Modifications to the DTC
Asurion Headquarters
19 – O’Connell
Chuck Gannaway, with Hastings Architecture Assoc.
Randy Roberson, with Highwoods Realty LP

APPLICANT REQUEST

Downtown Code DRC Meeting of 10/4/2018

Perspective Rendering from 11th Ave N.

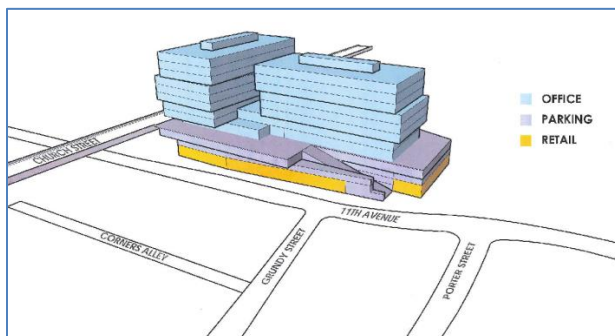
The DTC requires buildings greater than 4 stories to have a 15' stepback occur at some point between the 4th and 8th stories. The proposed project does not meet this stepback requirement. Rather than stepping the building back, the applicant seeks approval for a portion of the building to cantilever beyond the build-to line between the 4th and 6th stories along Church Street. The remaining 7th – 9th stories are to be built to the build-to line. The extruded portion cantilevers to a maximum of 11' within the bridge easement and does not encroach into the public right-of-way.

- The existing bridge easement along the Church Street viaduct presents a unique condition whereas the allowable buildable footprint is constrained in this area. The proposed building is built to the back of the easement.

- The overall height of the building at 12 stories is well below what this sub-district would otherwise permit (up to 15 stories).
- The building layout responds efficiently to the shape of the lot in the form of a T-shape configuration and maintains a well-defined street edge.

- The massing contains two tower elements separated by a large open space that allows for light and air to penetrate through the building and onto the street.

- Each tower is composed with stacked or cantilevered sections that further break up the massing and give a unique quality to the building. The architectural expression promotes a more interesting interaction between the private and public realm.

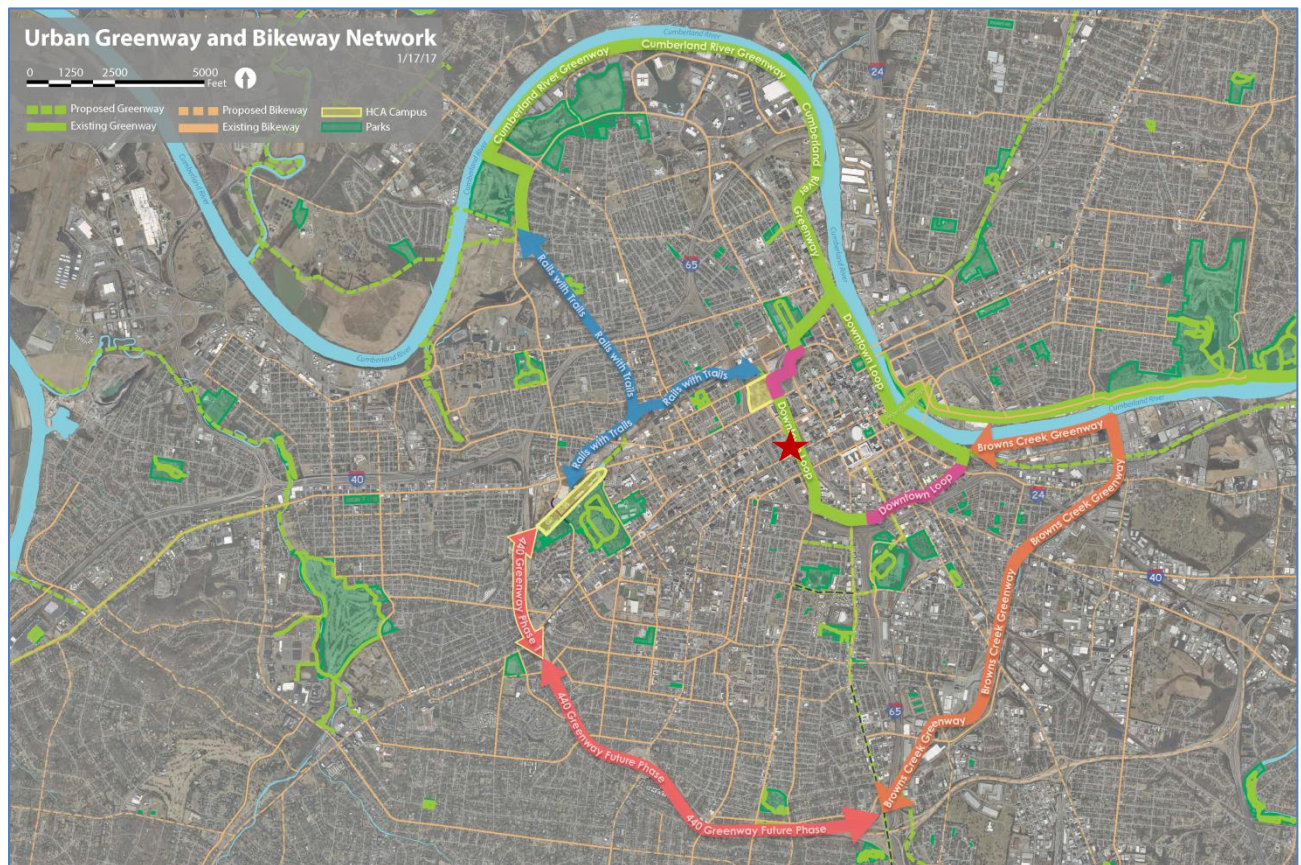
The site is bounded by the Church Street viaduct to the north, 11th Avenue North to the west, CSX right-of-way to the east. The site plan proposes to subdivide the lot so that the parcel to the south may be developed separately and at a later time. An unbuilt segment of the City Central Greenway System is also planned to traverse the property.

The site receives vehicular access from three points - one in alignment with Grundy Street, a second at the north end of the site, and a third at the third level to the west side of the site. Valet and drop-off area occurs on-site at the third-level entry.

Pedestrian access is provided at several points as well. A primary entrance is provided from Church Street and 11th Avenue North. A proposed connection to the Church Street viaduct allows pedestrians to enter the site and onto a monumental staircase that leads down to 11th Avenue North, where the building is lined with several retail entry points.

This site is unique because the property contains a significantly large amount of frontage along three sides of the lot. The total length of frontage is approximately 1,500' and includes 405' along Church Street to the north, 610' along 11th Avenue North to the west, and 560' along the Greenway to the east. The project successfully creates an interactive environment along Church Street, connecting to the viaduct at two points due to the incline of the bridge. While 11th Avenue North is designated as a Tertiary Street by the DTC, active use is encouraged by the Code, but it is not required. The project proposes activation of 11th Avenue North, and staff supports the activation of 11th Avenue North over the greenway, given existing conditions in the area. 11th Avenue North is building out as an activated frontage, while the City Central Greenway, along this segment, has been constructed primarily along inactive frontages to the rears of buildings.

The project offers unique qualities and architectural expression in its site configuration, building form, and massing. Several points of concern remain with the lack of active use and blank façade proposed along the greenway frontage. A design alternative to the façade along the greenway should promote both a safe and enhanced pedestrian experience.

1. The relocated stairway should not be an isolated element but rather a much stronger and robust design component that integrates with the building and aligns with the future street crossing at Church Street.
2. The façade along the Greenway should not be left exposed and should be screened appropriately and integrated with the remainder of the building. In lieu of an active use, the façade should incorporate design elements that would enhance the pedestrian experience along the greenway. A mixture of various design elements might include, but is not limited to, the following: integrated stair or ramp to activate the frontage, a mural wall, architectural screening, landscaping, and/or a dedicated bike facility area.
